**ADDITIONAL TECHNICAL  
INFORMATION**

**Hollywood Park Racetrack and Casino  
1050 South Prairie Avenue  
Inglewood, California**

Subject: Additional Technical Information  
Hollywood Park Racetrack and Casino, 1050 South Prairie Avenue,  
Inglewood, California, SLIC Number 1207  
(EKI A50015.01)

Proposed Monitoring Well and Soil Sample Locations

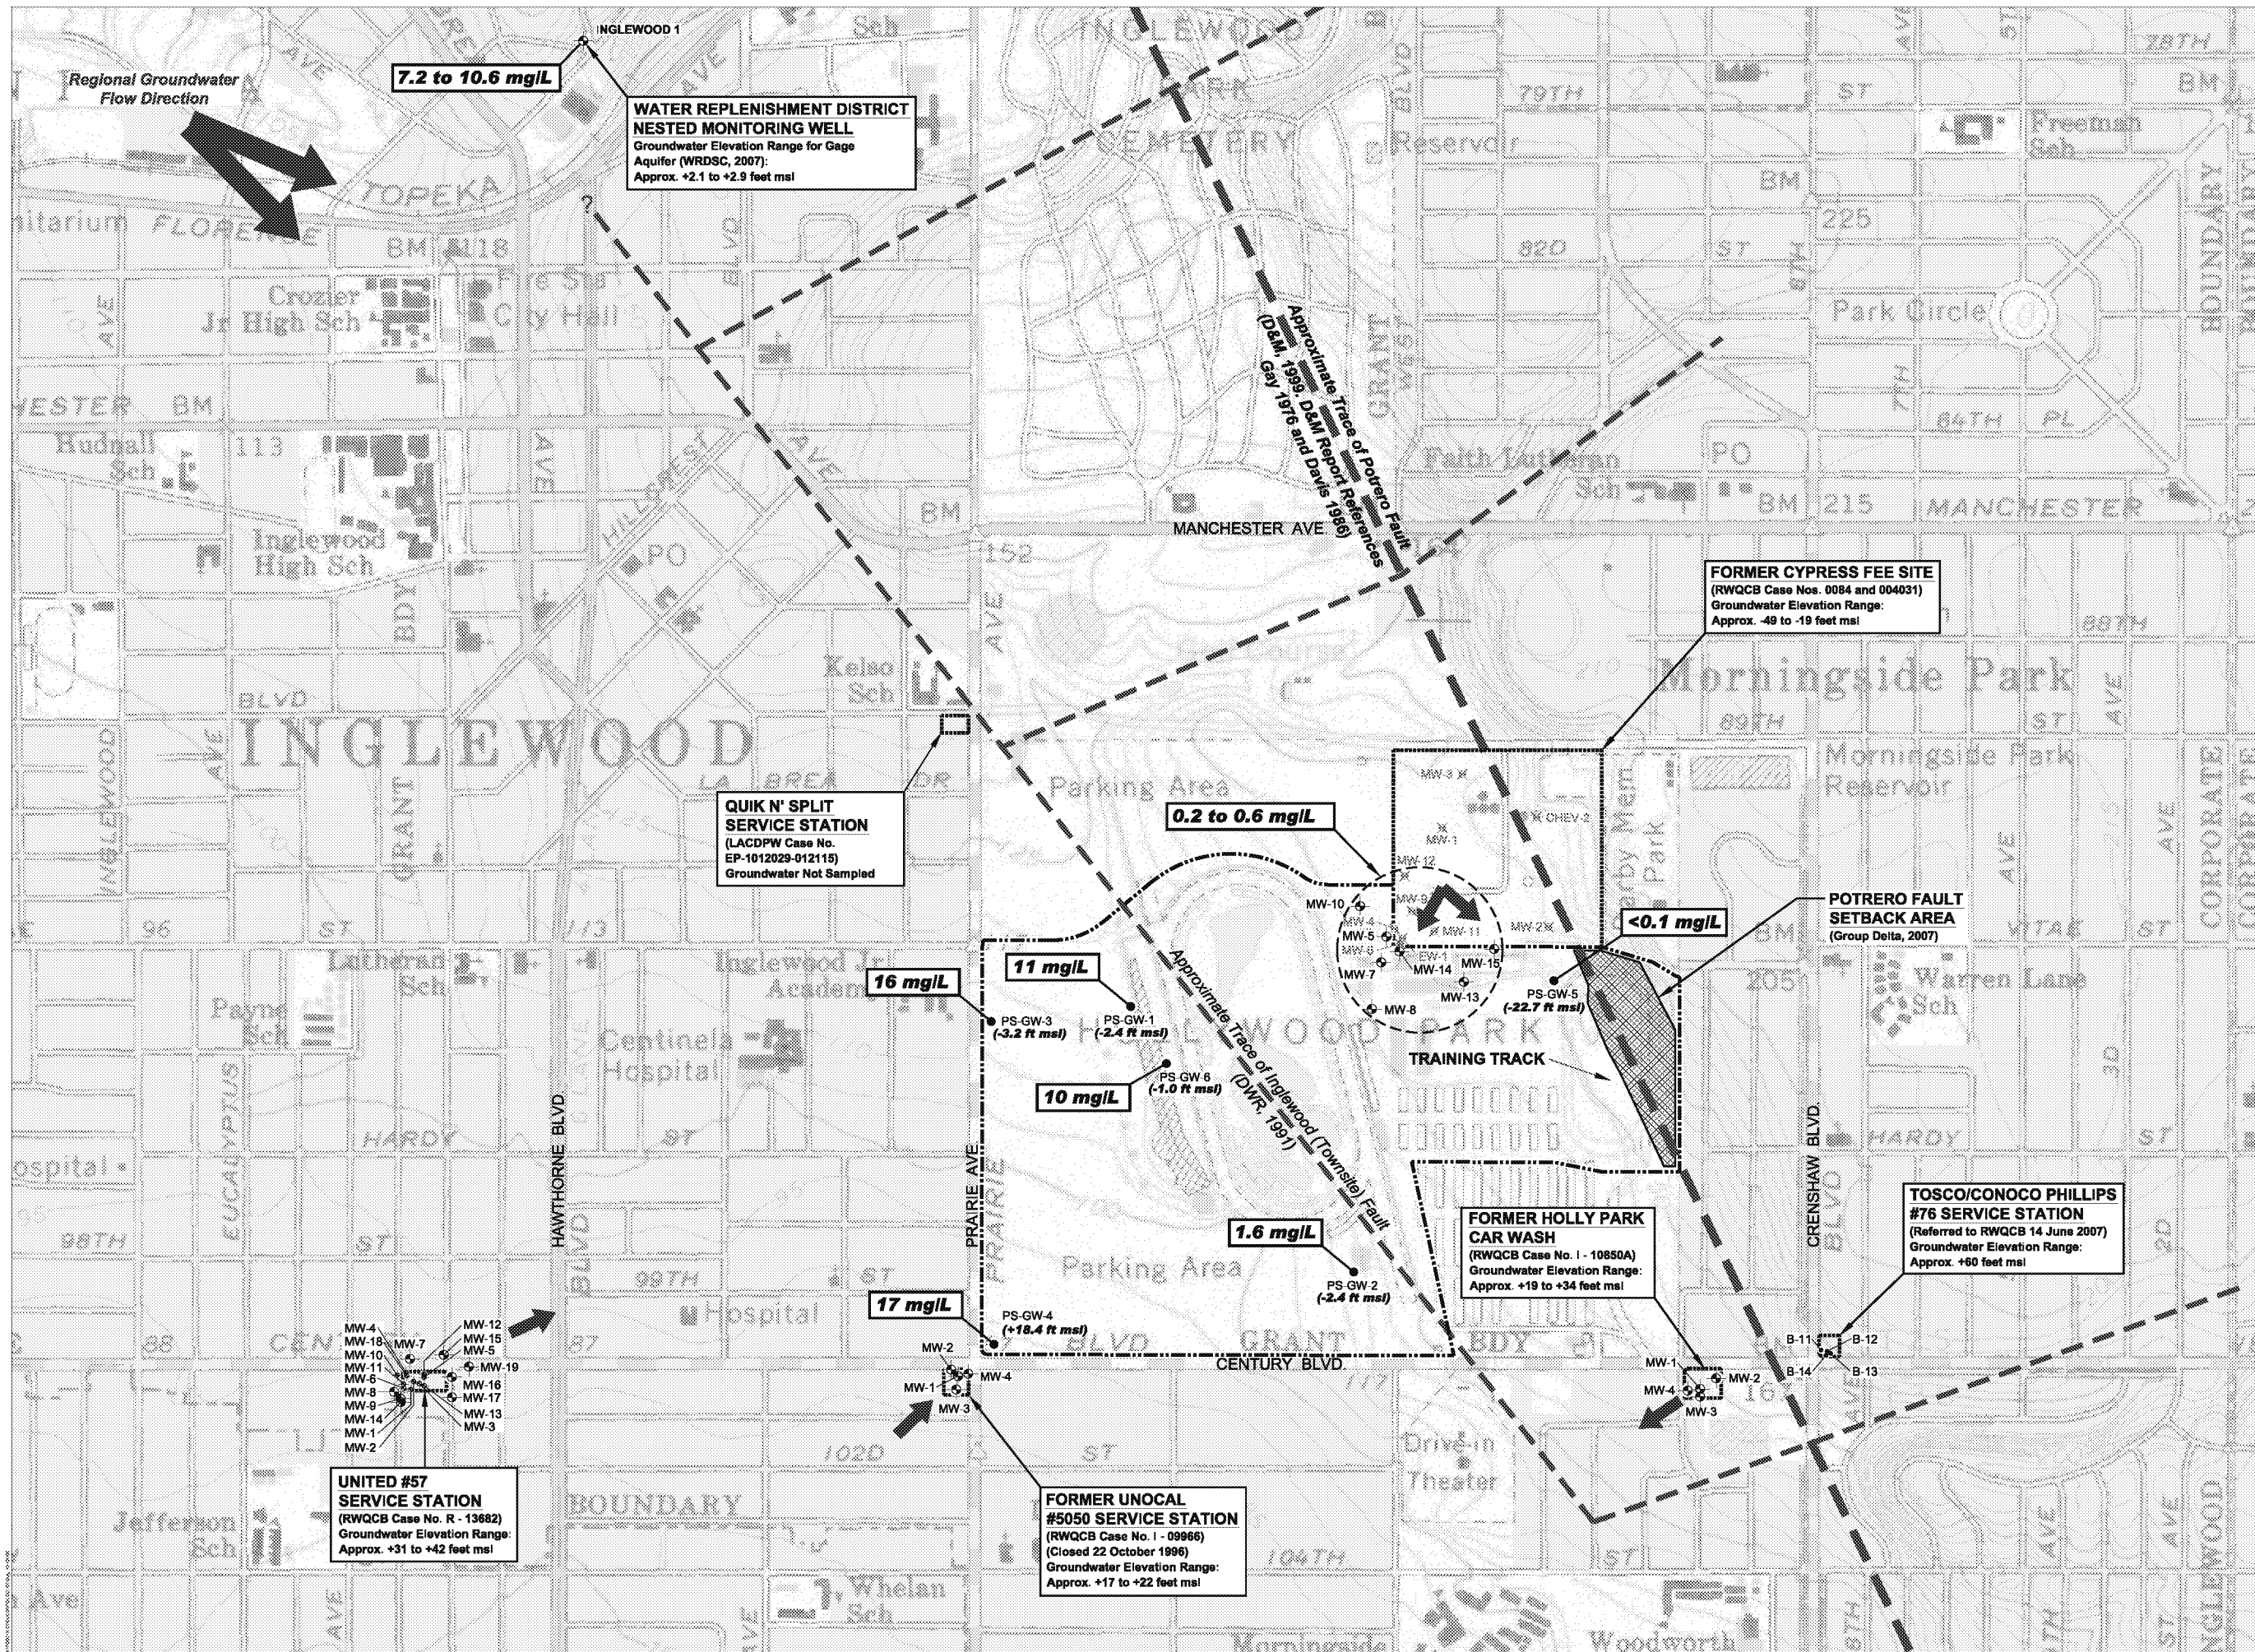
- The highest concentration of nitrate (17 mg/L of nitrate as nitrogen) was detected in the grab groundwater sample collected from the southwestern corner of the Property, as shown on Figure 2. This sample also contained total petroleum hydrocarbons (“TPH”) that are believed to be migrating onto the Property from the former Unocal #5050 station located across the street from the Property to the southwest, which was closed by the RWQCB in October 1996. Several hundred micrograms per liter (“µg/L”) TPH remained in groundwater at the Unocal station at that time, as discussed in the Technical Report and Work Plan. In its 22 August 2008 letter, the RWQCB agreed that the TPH-impacted groundwater on the southwestern portion of the Property appears to be migrating onto the Property from the Unocal #5050 station area. Therefore, the nitrate found in this same grab groundwater sample is also believed to reflect the quality of groundwater migrating onto the Property in this area.

- Groundwater west of the Inglewood (Townsite) fault trace is believed to be migrating onto the Property generally from the west, as shown by the data for the Unocal #5050 site that were presented in the Technical Report and Work Plan, and as shown by the regional groundwater gradient on Figure 2.

Work Plan to accommodate access and land planning constraints. Figure 2 reflects the updated proposed monitoring well locations. Further, HPLC plans to conduct the quarterly groundwater monitoring and reporting for the four originally proposed monitoring wells, as approved and requested in the 13 August 2008 RWQCB letter. HPLC will inform RWQCB staff when drilling for the four monitoring wells is scheduled.
